DESIGN REVIEW COMMITTEE

May 15, 2024 6:00 PM

4.I. 3335 Dogwood Drive New Townhome Development

4.II. 3637 Elm Street Request for Design Exception

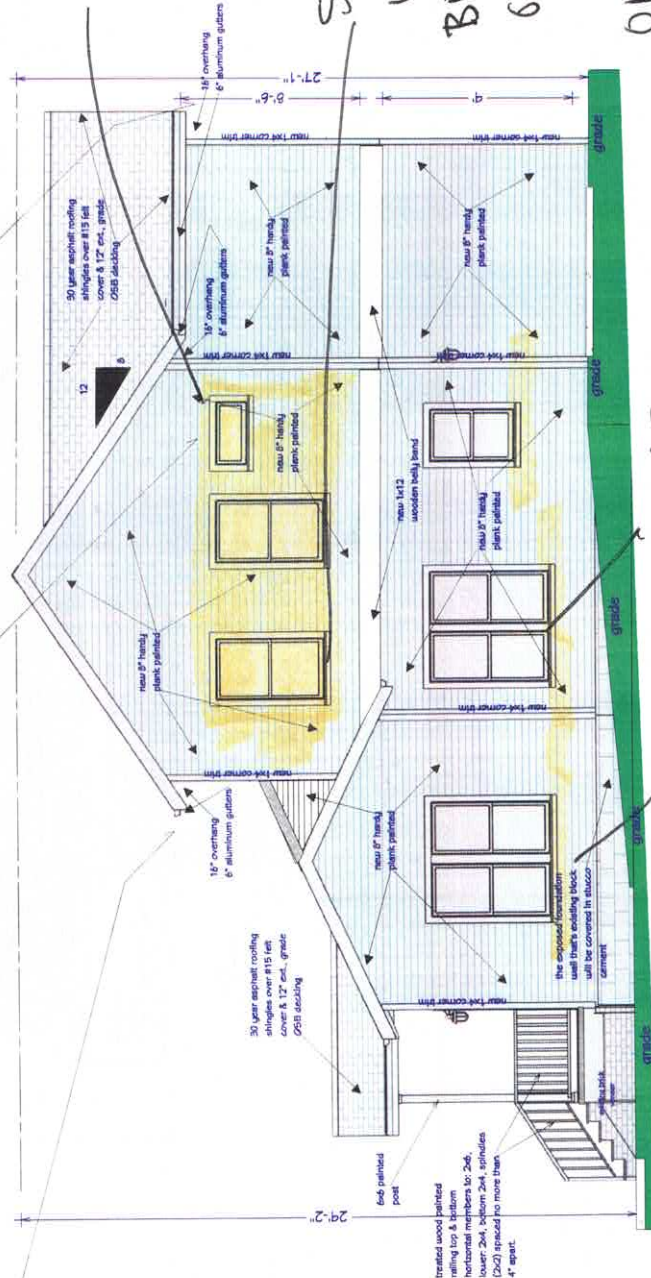
Why duplicated?

ADDED
WINDOWS.

STOW 2 REG
WINDOWS
BUT ONLY
ONE INSTALLED

PHOTO 4/29

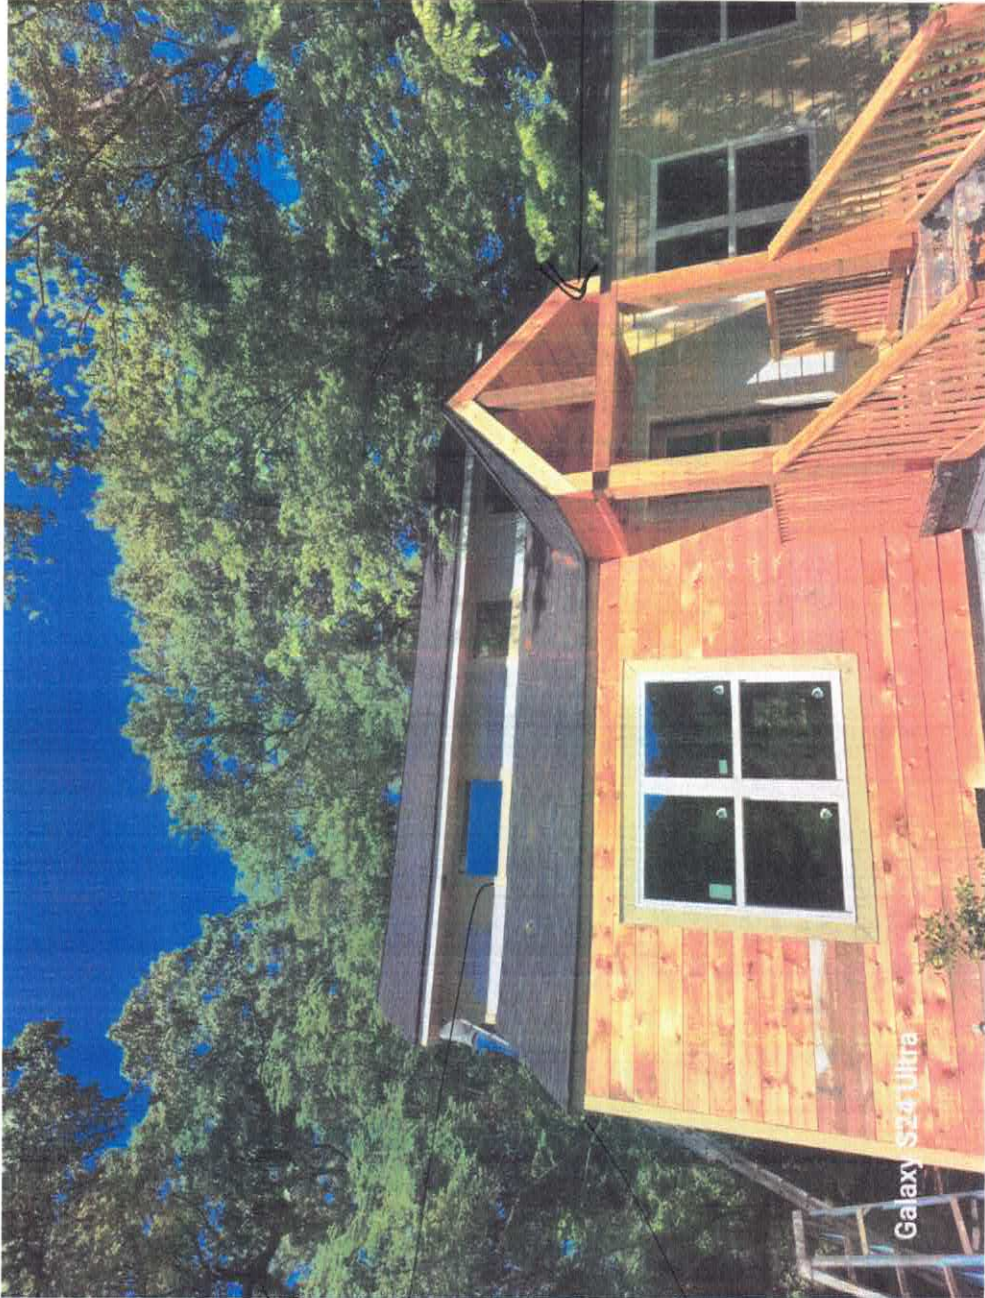
Window size
different

NO
OVERHANGS

PHOTO 5/10

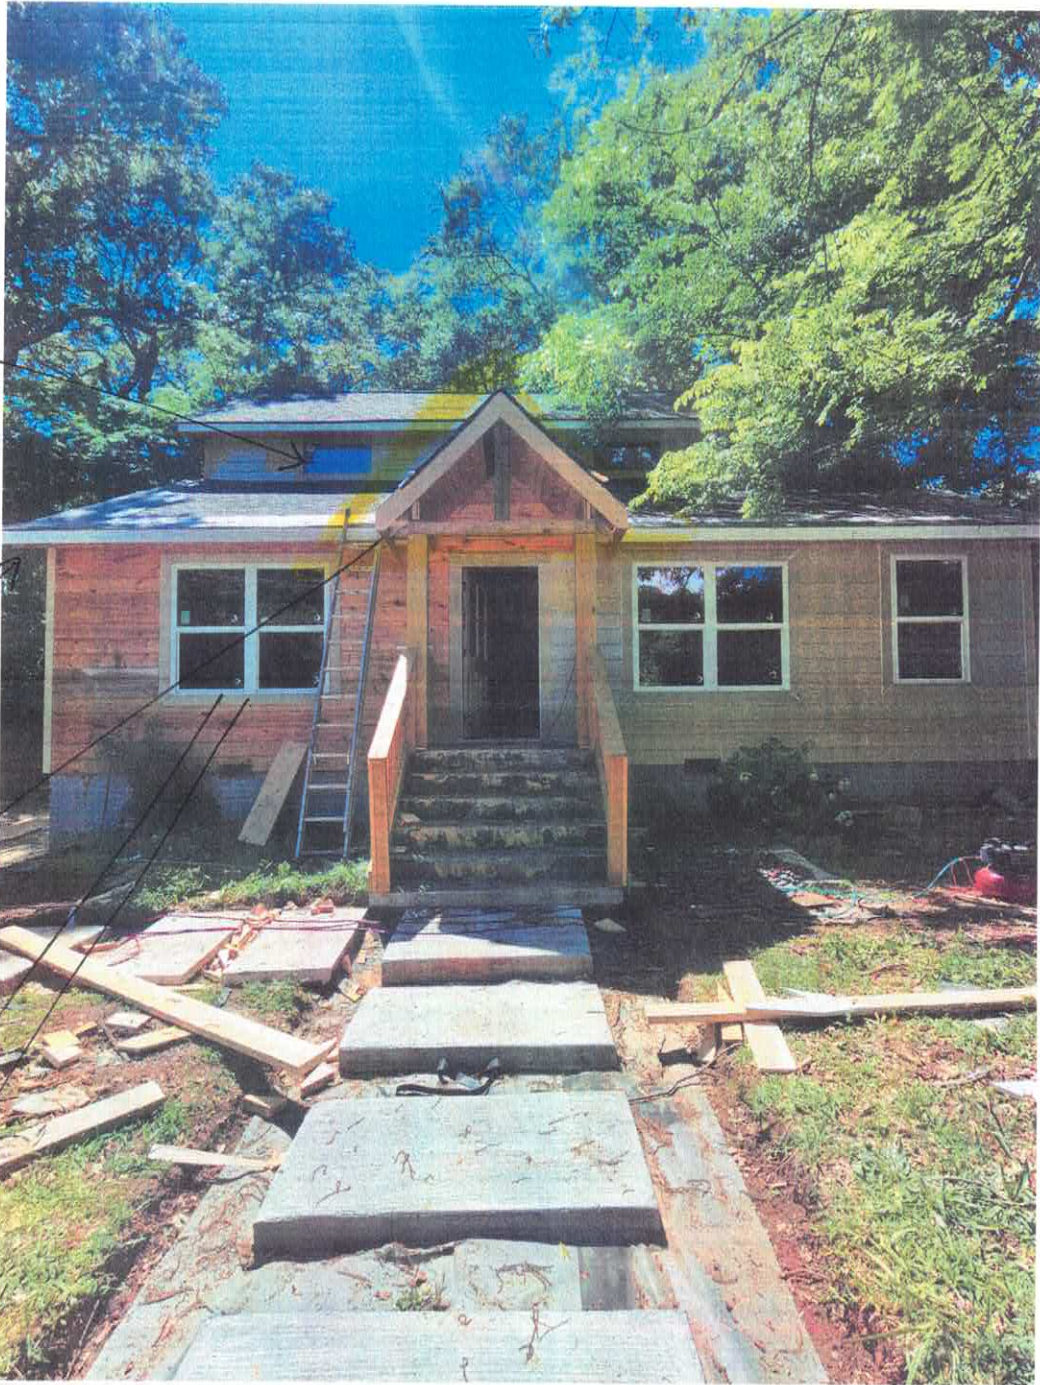
Window
Size
change

PHOTO 4/29
PER APPLICANT

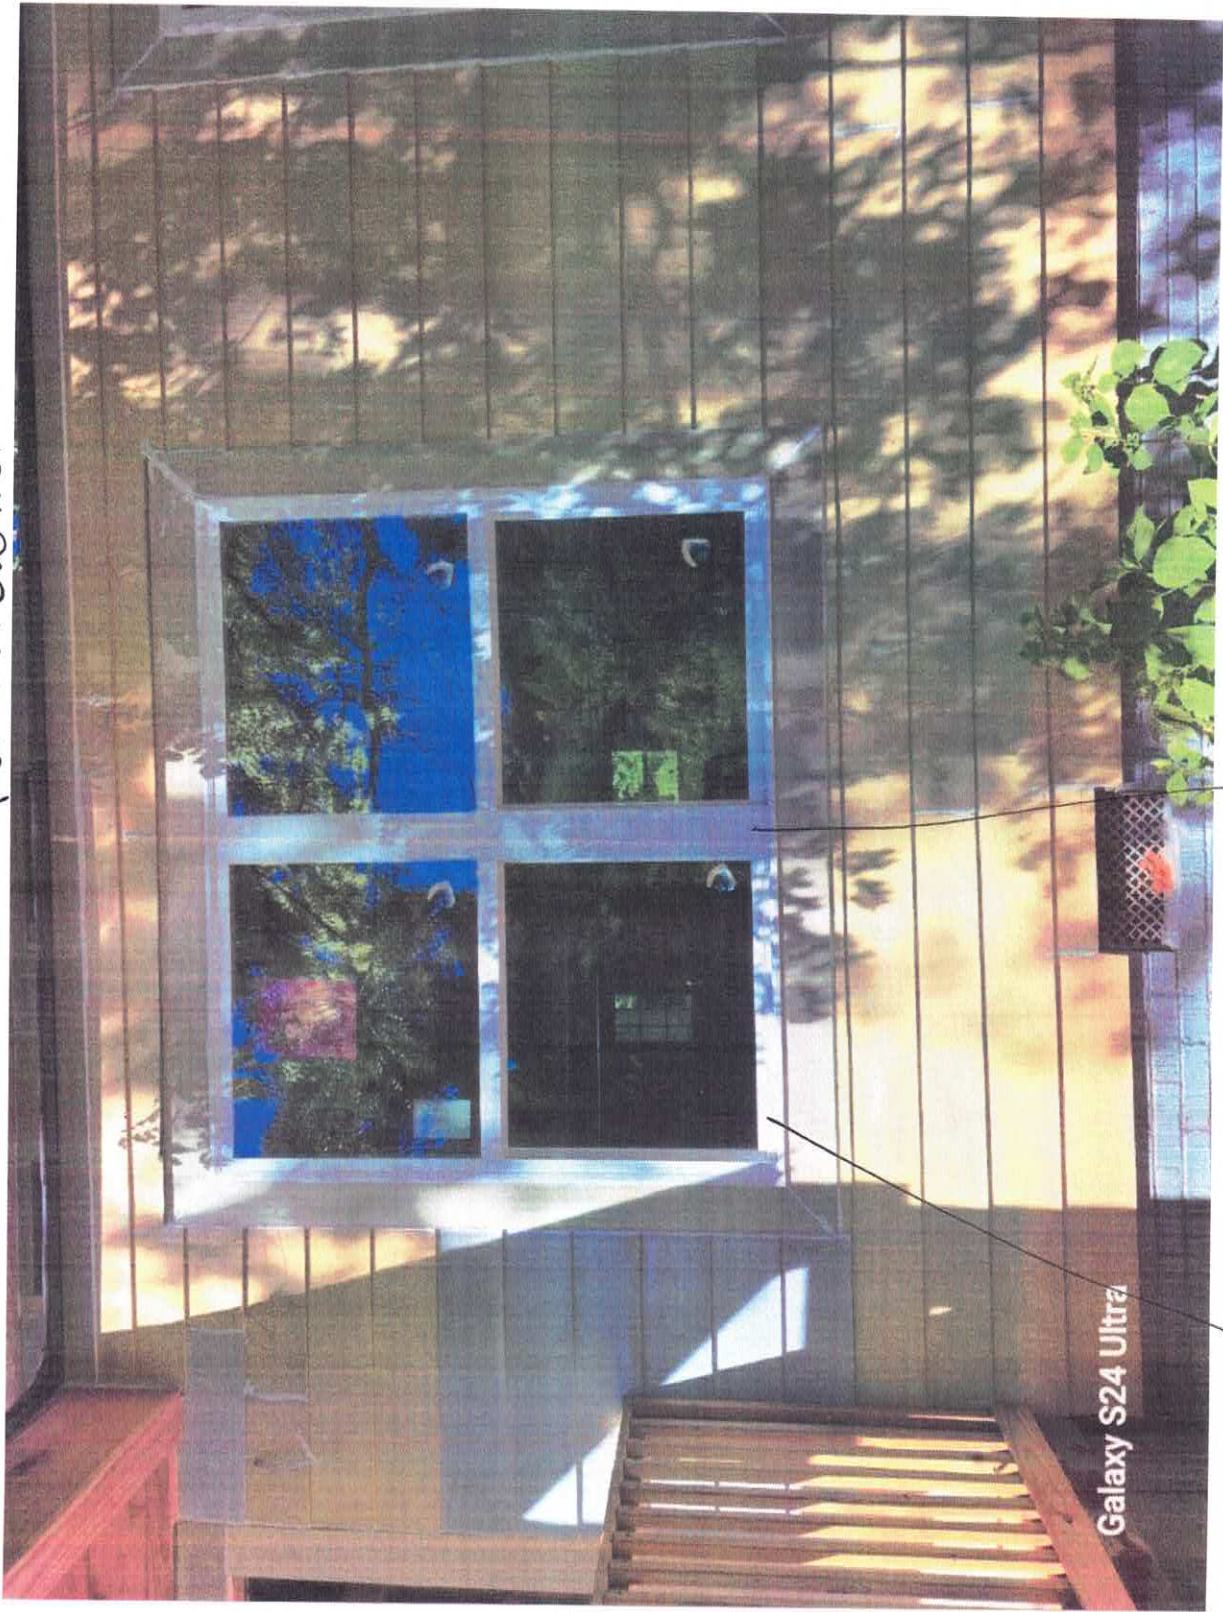
NO SILL

NOT 2" WIDER THAN SIDE?

Left Side

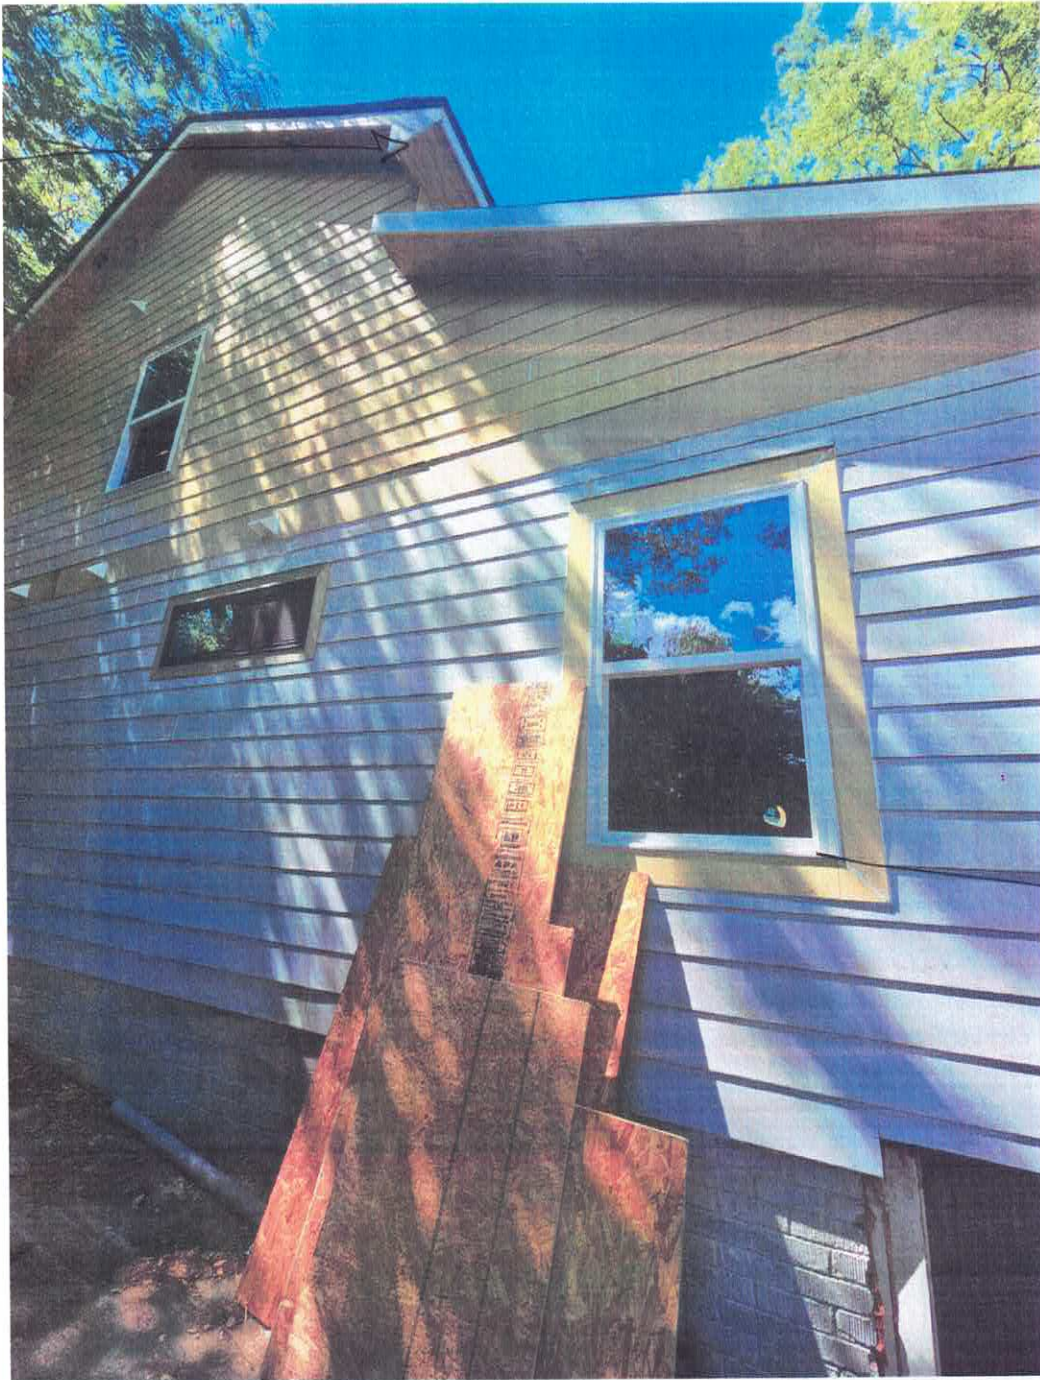
NOT SLOPED
SOFFIT

WINDOW
EXTENDS
IN FRONT
OF TRIM.

Right Side

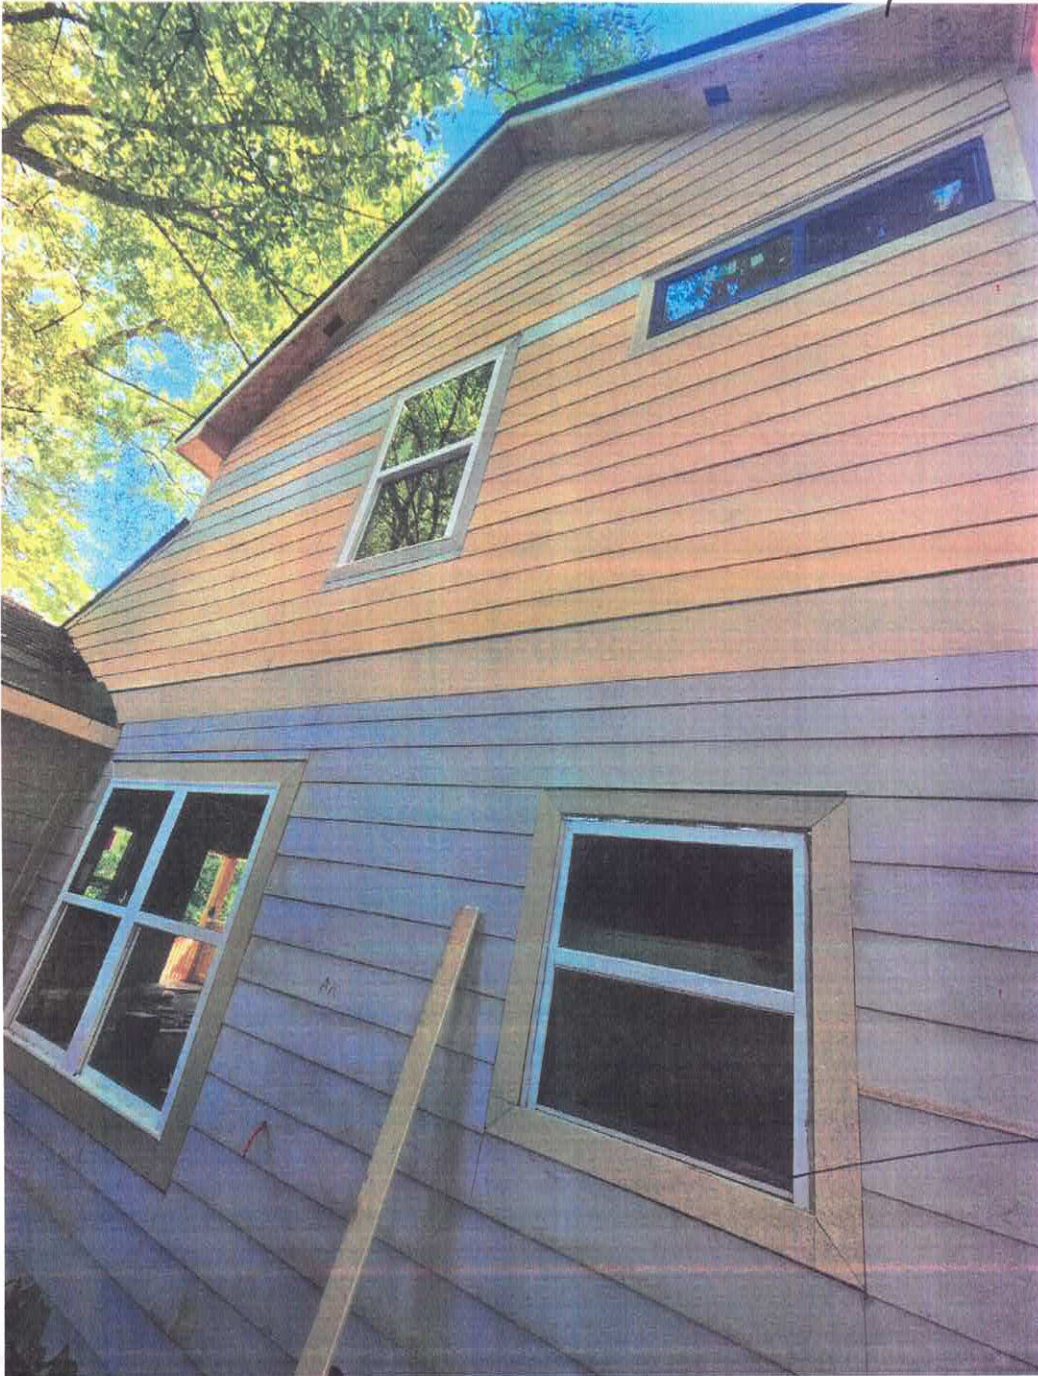
APPEARS.
RECESSED
OK?
